TP 14566 - Public Notice
Child Restraint Systems
2021-P02 E
December 20, 2021

Clek Foonf and Fflo Convertible Car Seats – Foam seat cushion may create choking hazard

Figure 3. EPP foam seat cushion with plastic insert installed

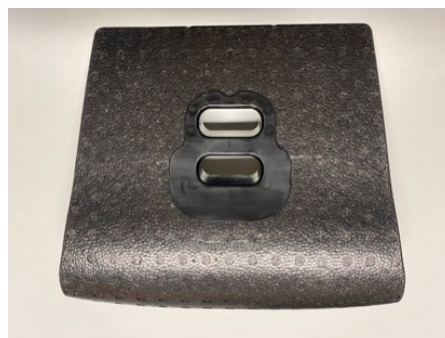
Clek Inc. wants the public to know that it is possible for a child to place their fingers through the crotch buckle opening and pick at the foam seat cushion on the subject car seats. After repeated picking, a child may be able to remove small pieces of Expanded Polypropylene (EPP) foam and put the small pieces into their mouth, nose or ear.

In order to avoid this risk, Clek has designed a plastic insert to cover the foam around the crotch buckle opening. The company will provide affected car seat owners with a kit to fix the issue.

All Clek Foonf and Fillo car seats made on or after May 21, 2021, have this plastic insert.
